PCN N° 2021-165-A

Introduction of an additional assembly and final test location at HYME for CoolMOS™, package TO252/251-3

3cip PCN_2021-165-A

3cip PCN_2021-165-A IPAK long lead (TO251-3) POD Comparison

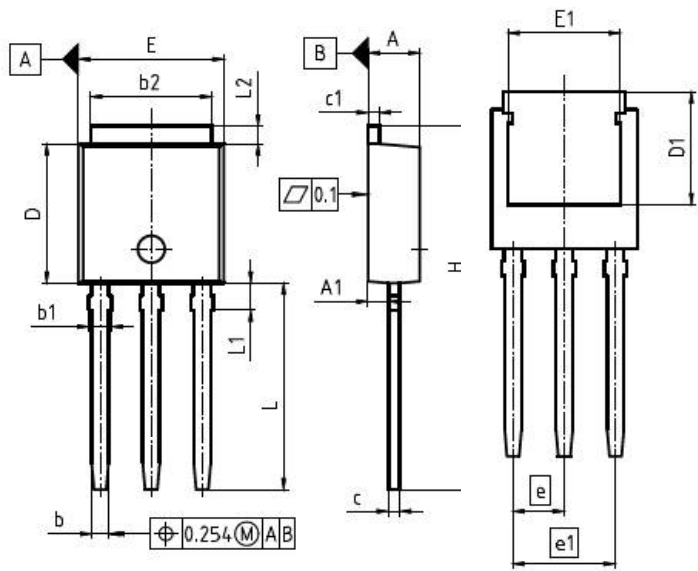
Due to HYME, the package dimension in the IFX datasheet was amended for L1min from 1.9 to 0.85mm and L2min from 0.89 to 0.88mm
